UNITED STATES PATENT AND TRADEMARK OFFICE

APPLICATION NO.	FILING DATE	FIRST NAMED INVENTOR	ATTORNEY DOCKET NO.	CONFIRMATION NO.
10/730,852	12/09/2003	Kiyonori Oyu	ELPIDA 03USFP943	5218
27667	7590	12/13/2006	EXAMINER	
HAYES, SOLOWAY P.C. 3450 E. SUNRISE DRIVE, SUITE 140 TUCSON, AZ 85718			NGUYEN, THINH T	
			ART UNIT	PAPER NUMBER
			2818

Office Action Summary

DETAILED ACTION

Fig. 2 PRIOR ART

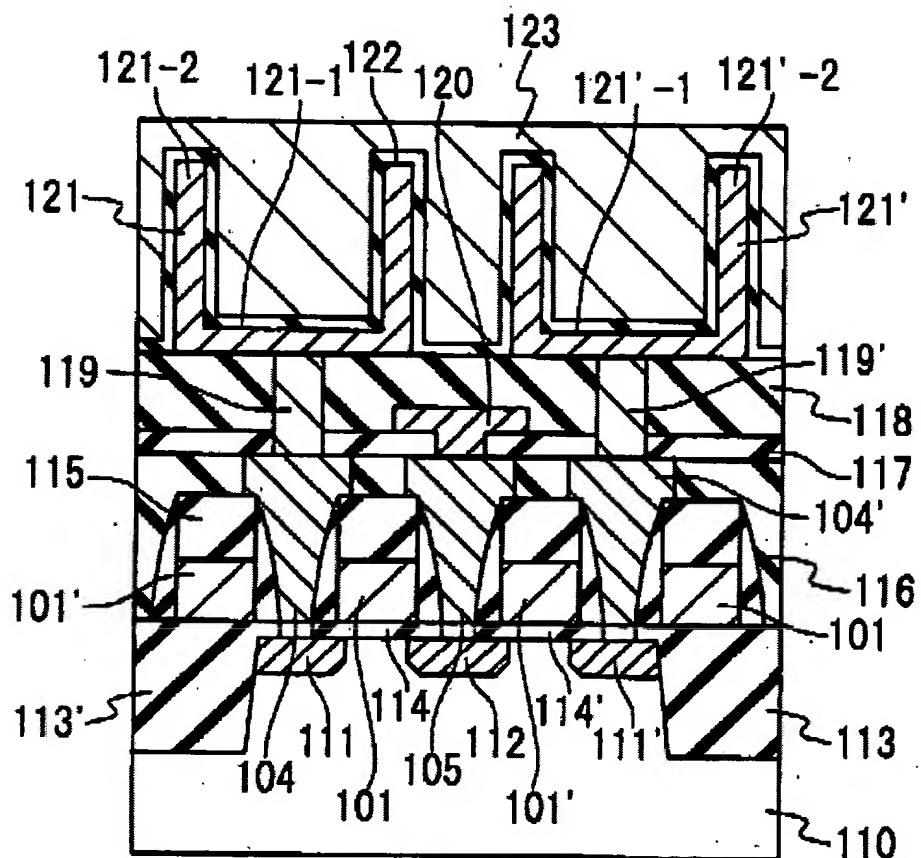
14. Claims 4-6 are rejected under 35 U.S.C. 103(a) as being unpatentable over Park et al. (U.S. Patent 6,396,096) in view of Applicant Admitted Prior Art or AAPA (Fig 2 of Applicant Application).

With regard to claim 4, Park discloses all the invention as set forth in the rejection of claim 2 except for going into detail about a first insulating film provided to cover the gate electrode; a first contact section formed to pass through the first insulating film to the first diffusion layer; a bit line formed on the insulating film; a second contact section formed to pass through the insulating film to the second diffusion layer, and a capacitive section formed on the first insulating film and connected to the first contact section. Applicant Admitted Prior Art, discloses a first insulating film provided to cover the gate electrode; formed to pass through the first insulating film to the first diffusion layer; a bit line formed on the insulating film; a second contact section formed to pass through the insulating film to the second diffusion layer, and a capacitive section formed on the first insulating film and connected to the first contact section.

It would have been obvious to one of ordinary skill in the art the time the invention was made to incorporated a first insulating film provided to cover the gate electrode; a first contact section formed to pass through the first insulating film to the first diffusion layer; a bit line formed on the insulating film; a second contact section formed to pass through the insulating film to the second diffusion layer, and a capacitive section formed on the first insulating film and connected to the first contact section of the AAPA into the Park et al. device since both Park and the AAPA are in the same endeavor of making DRAM.

Fig. 5

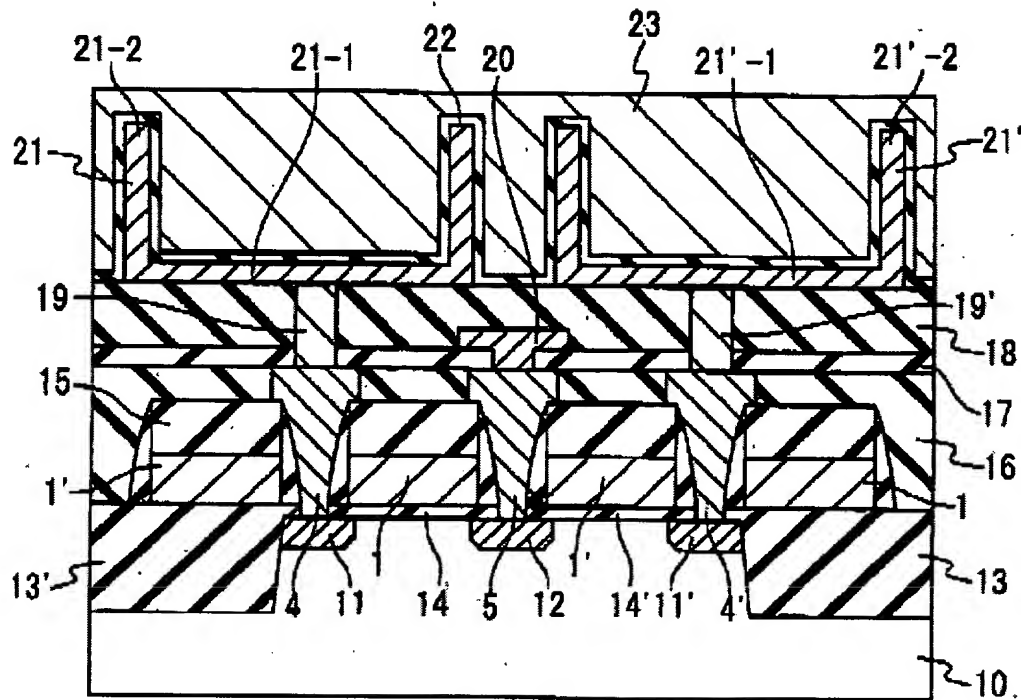
Park discloses (in the abstract, fig 5, column 4 lines 17-8, column 4 lines 64-67) a semiconductor memory device (Park discloses a DRAM or Dynamic random access memory) comprising: a semiconductor substrate; and gate electrodes formed for a transistor on the semiconductor substrate through a gate insulating film, wherein a gate length of said gate electrode is longer than a half pitch (or minimum processing dimension F).

Park discloses (in the abstract, fig 5, column 4 lines 64-67, column 4 line 29) a semiconductor memory device, comprising: a first diffusion layer formed in a surface of said semiconductor substrate to function either as a source or a drain and a second diffusion layer formed in the surface of said semiconductor substrate to function either as a source or a drain, wherein the shortest distance between said first diffusion layer and said second diffusion layer is proportional to said gate length.
